ADDENDUM NUMBER TWO

**Langan Park – Amphitheater Pavilion & Restroom
Project No: PR-031-21**

**Public Safety Memorial Park
Restroom, Skateboard Park & Splashpad**

OCTOBER 24, 2022

SHEET TITLE
 PAVILION
 PROPOSED NEW
 WORK PLAN

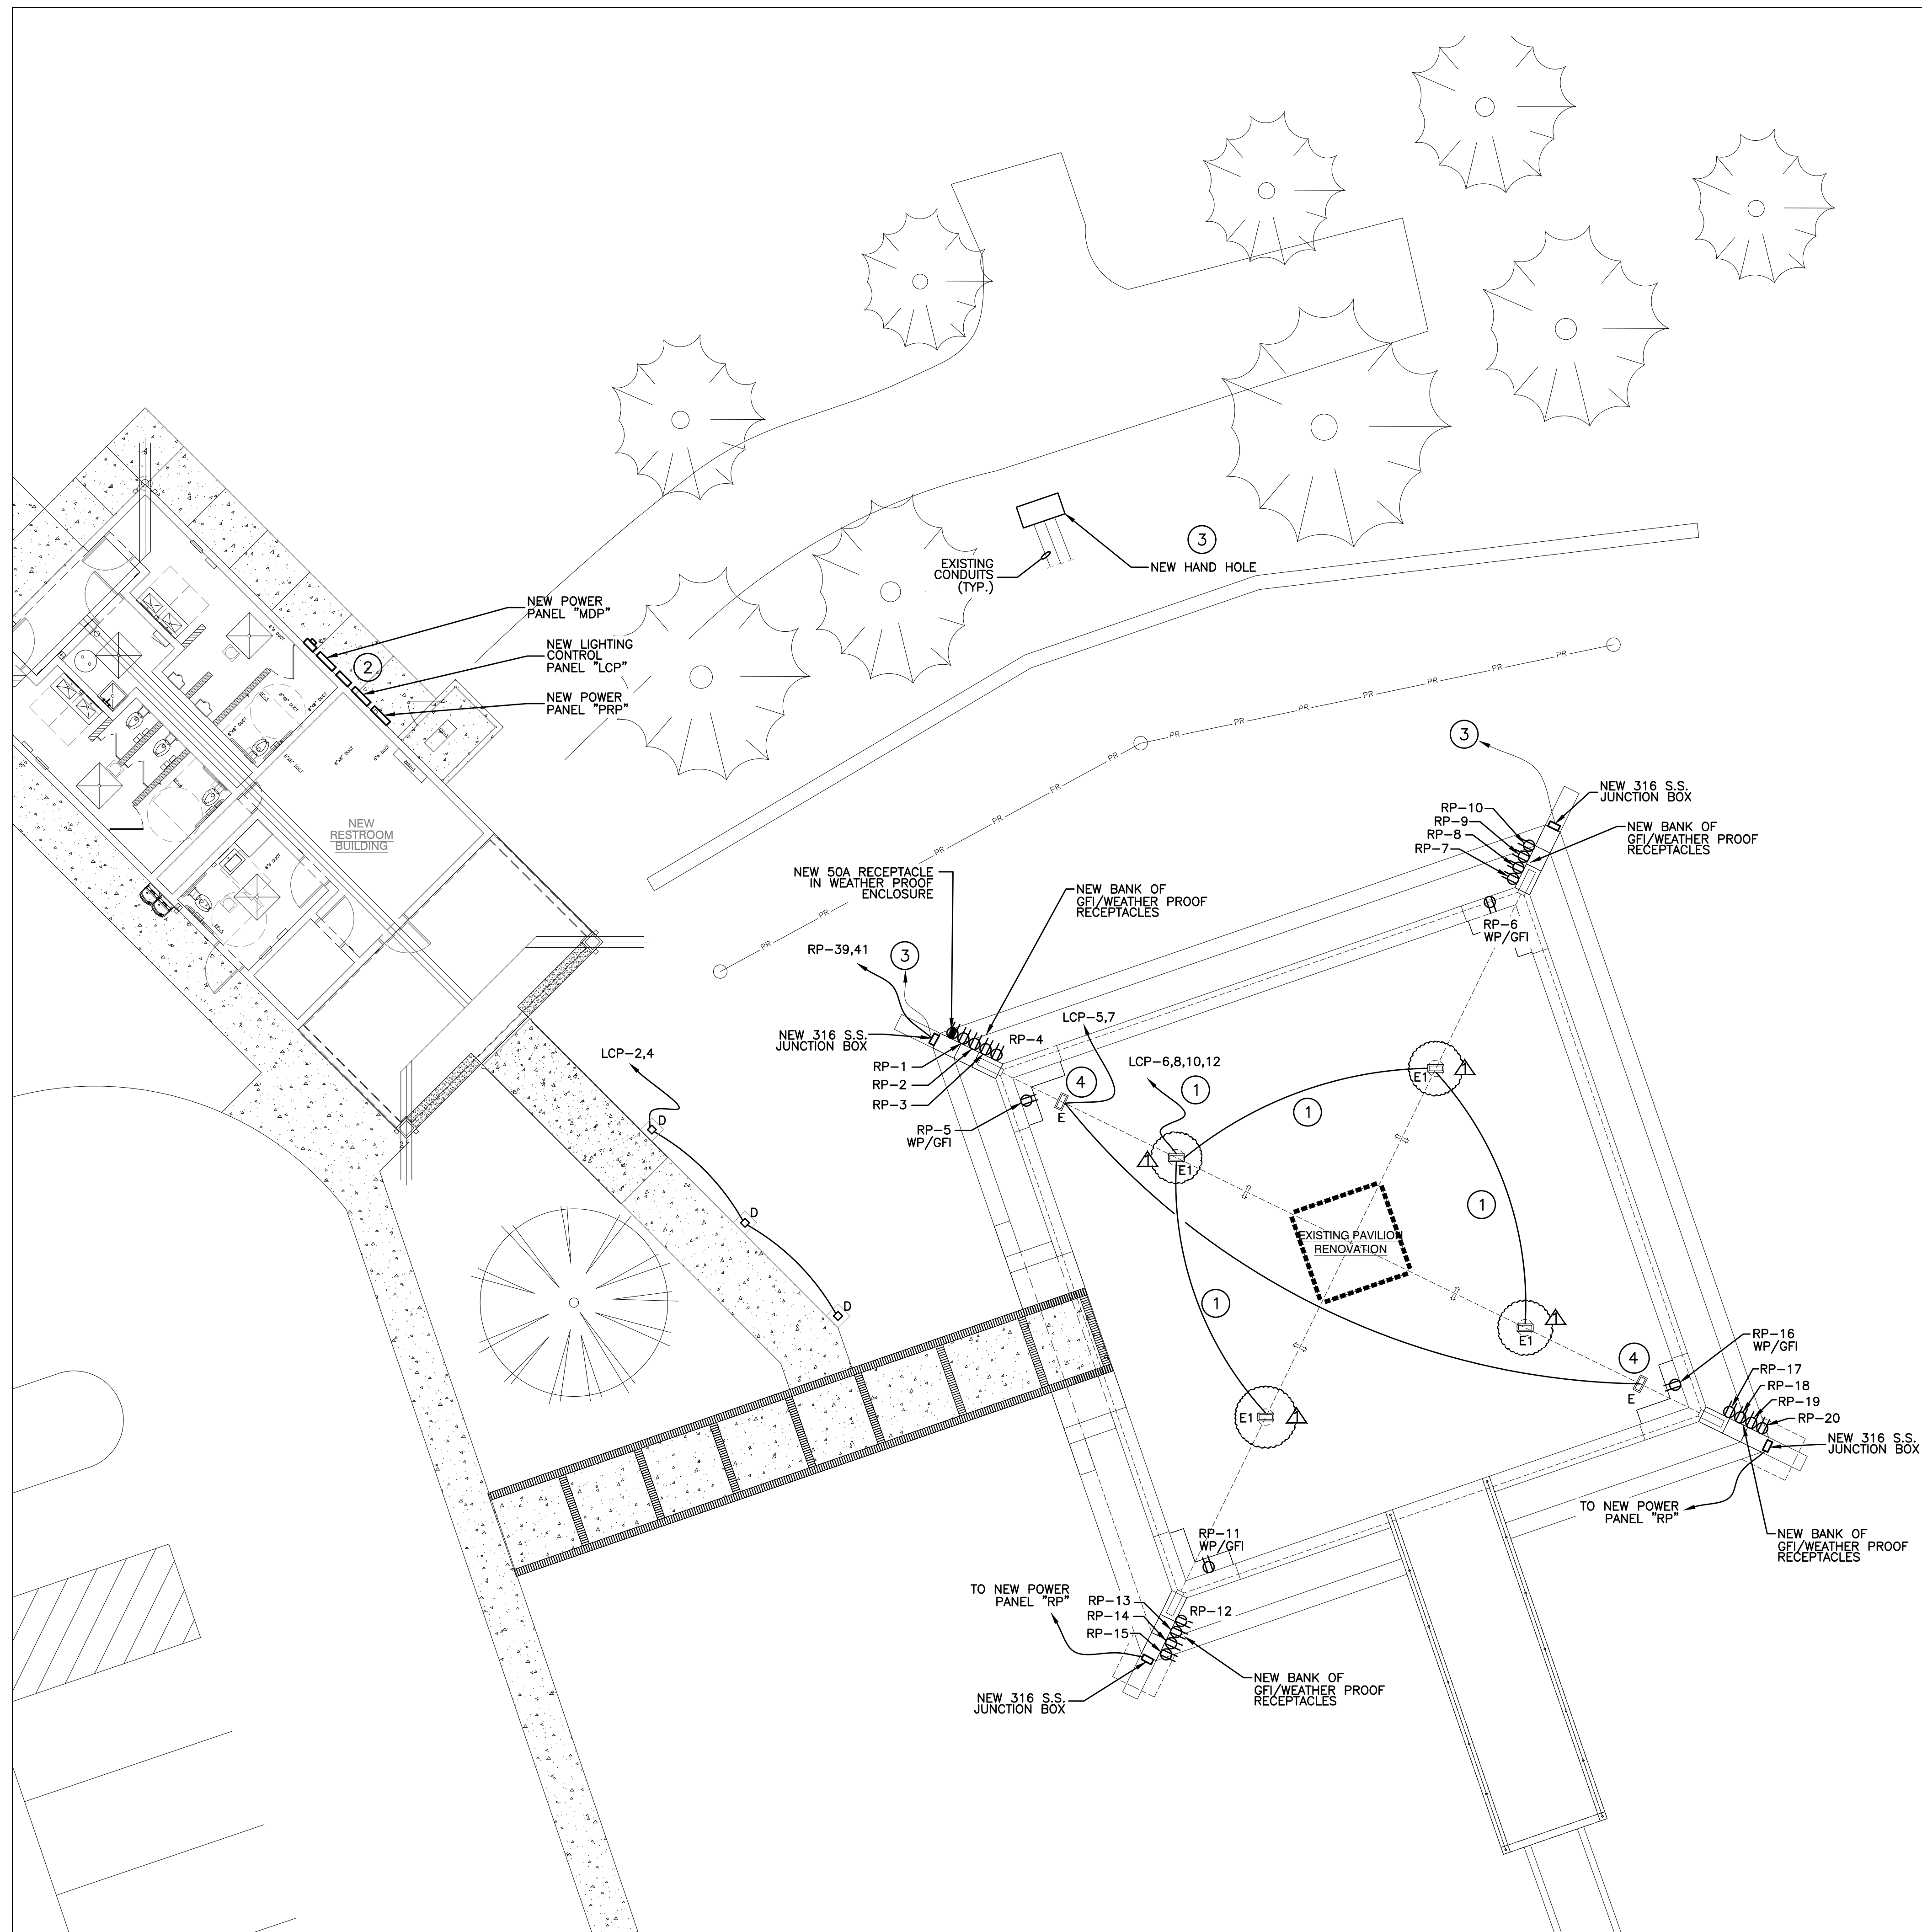
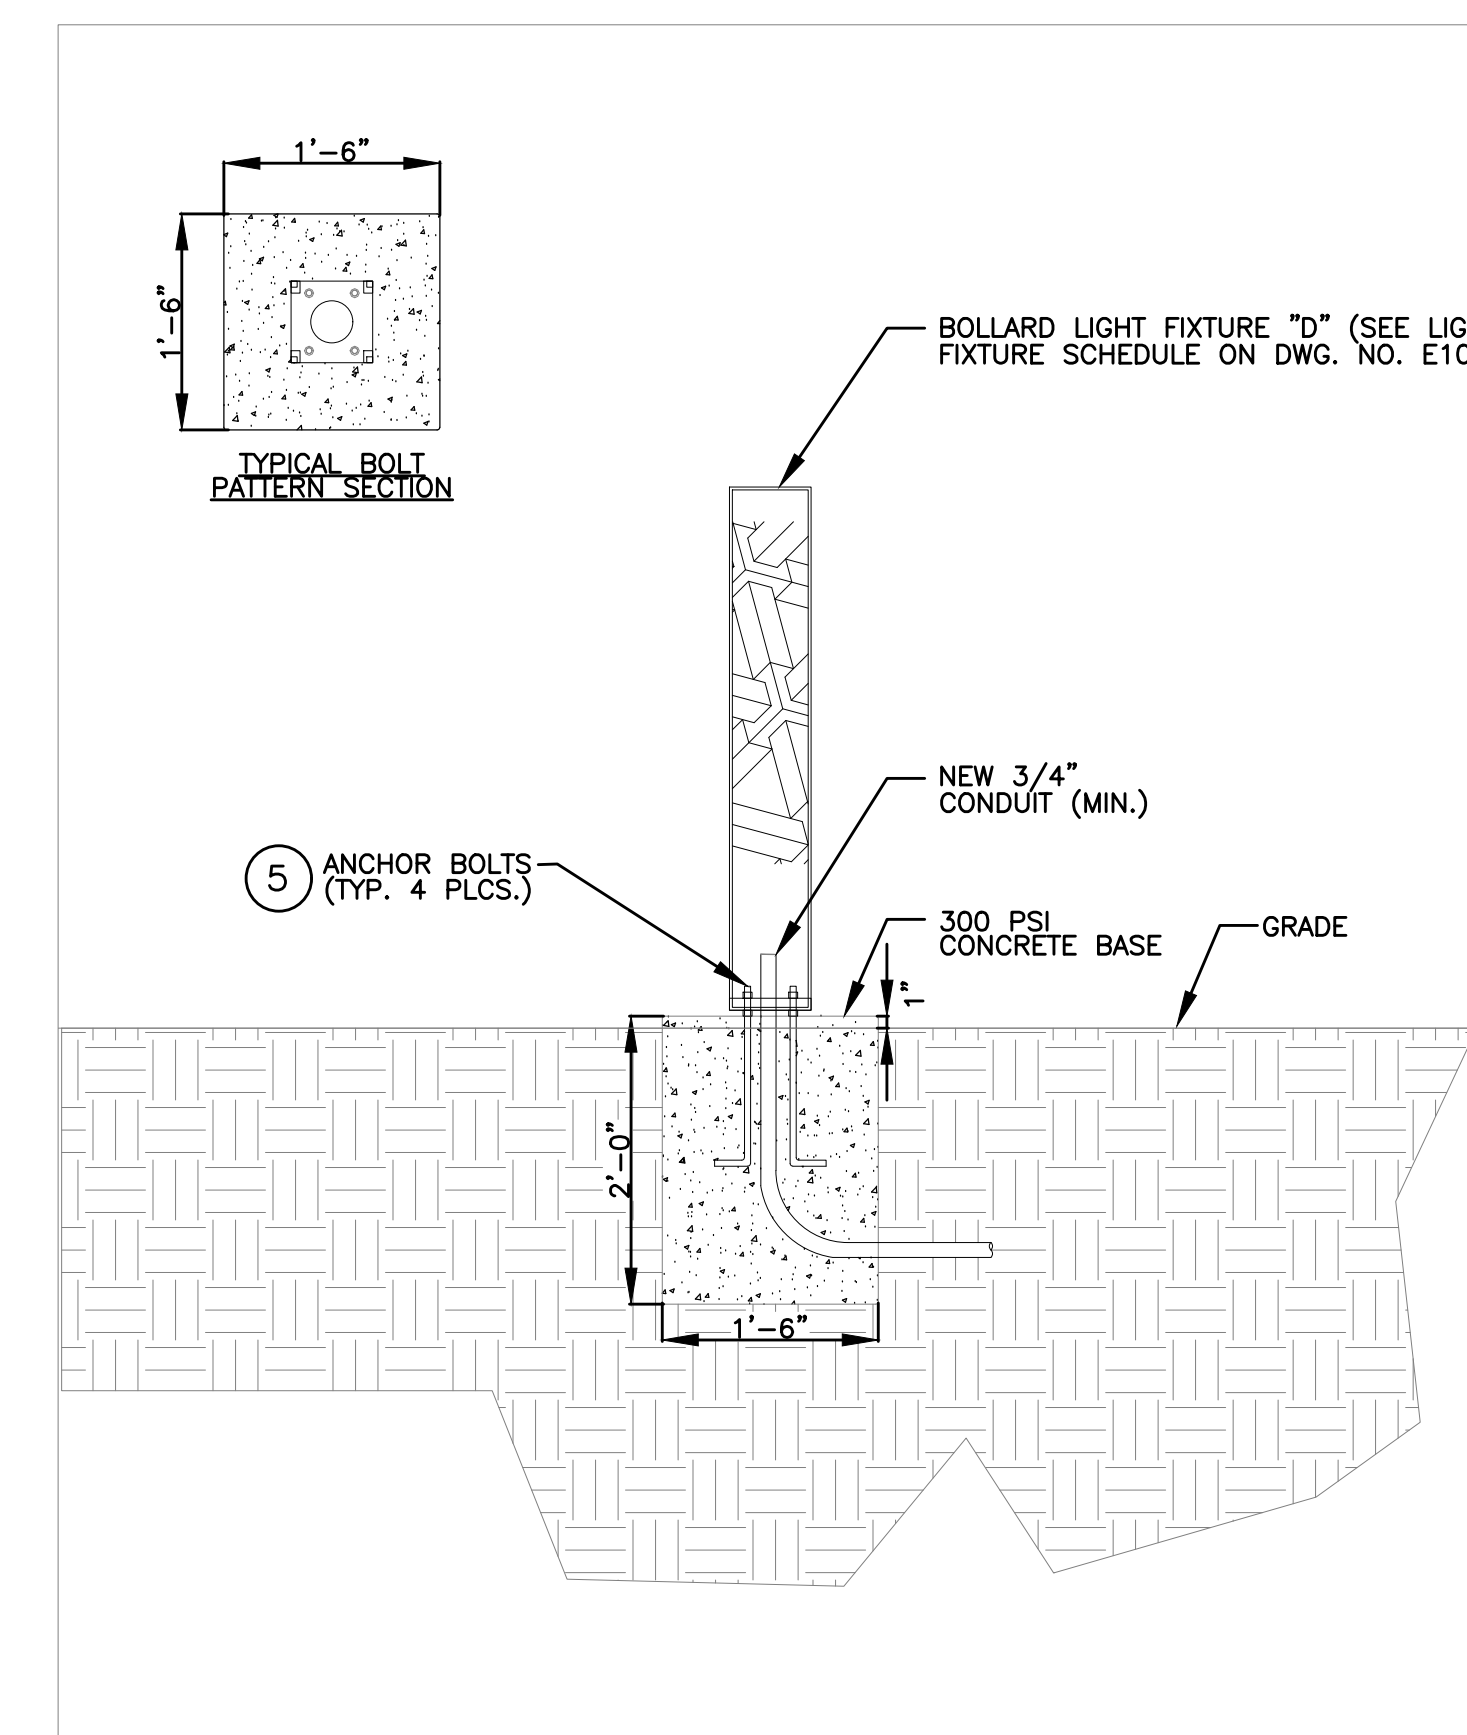
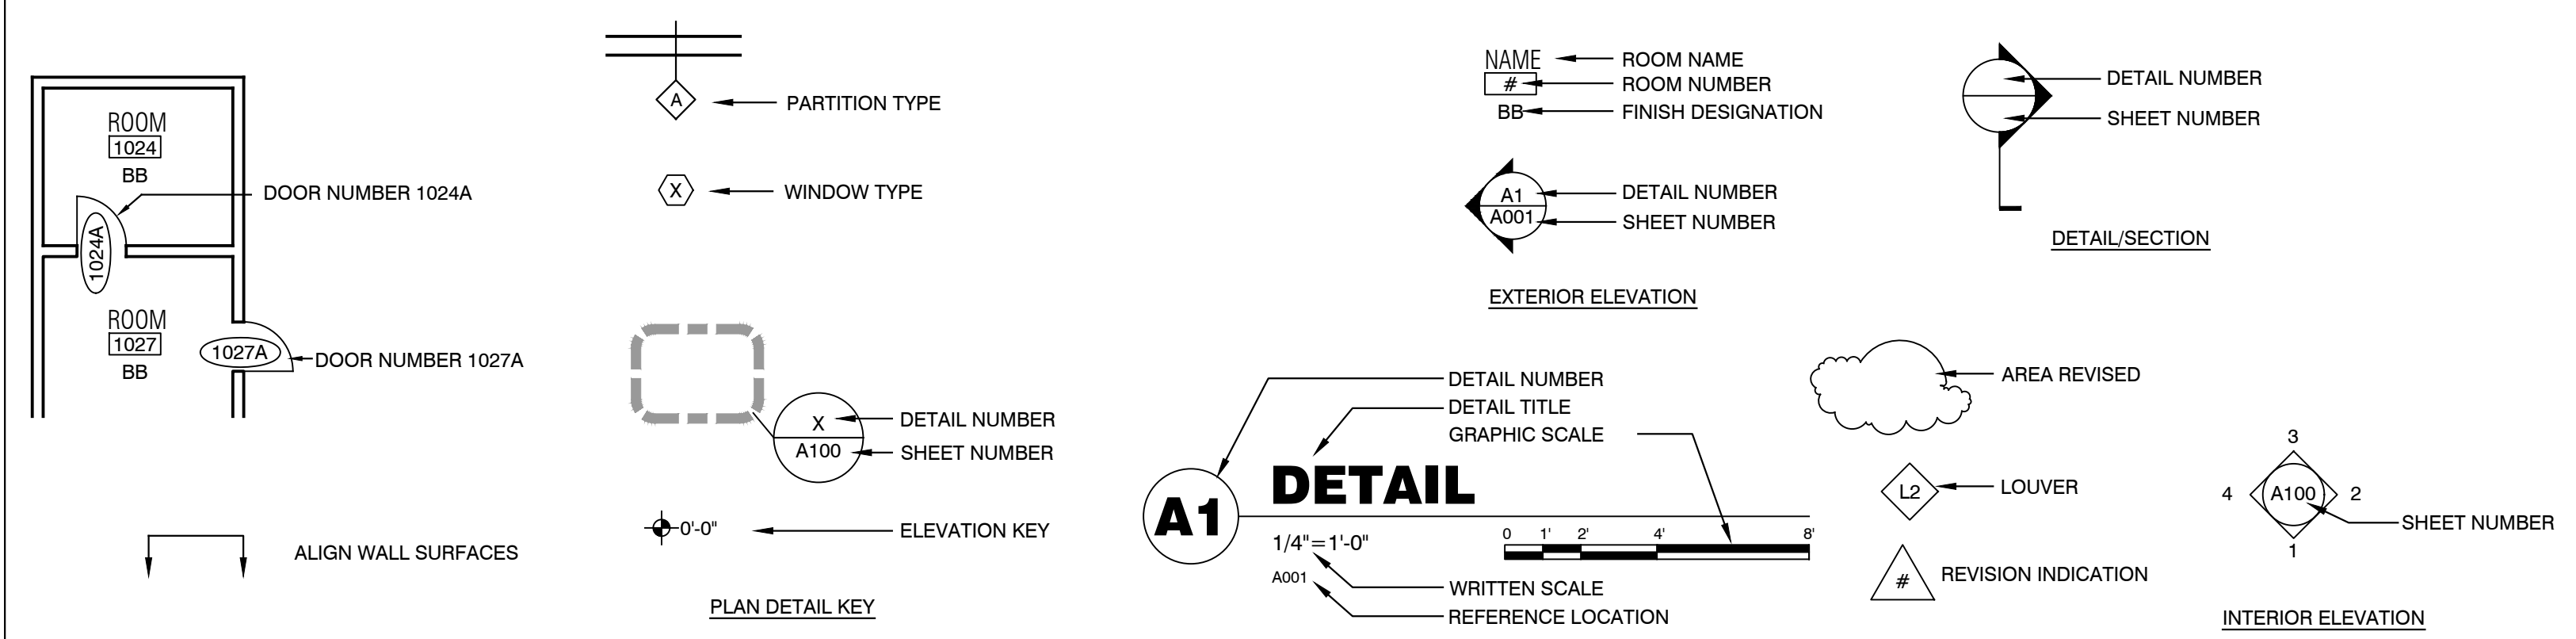
- 4.03 Reference attached *Drawing ES-103* – Pavilion Proposed New Work Plan for the following changes:
- A. The four (4) *Fixture "E"* in the center of the Pavilion (mounted approximately 30 feet above grade) shall be changed from *Fixture "E"* to *Fixture "E1"* and a dimmer switch shall be installed in the Lighting Control Panel to control the fixtures.

- B. The security light fixtures (mounted approximately 12 feet above grade) shall remain a *Type "E"*.
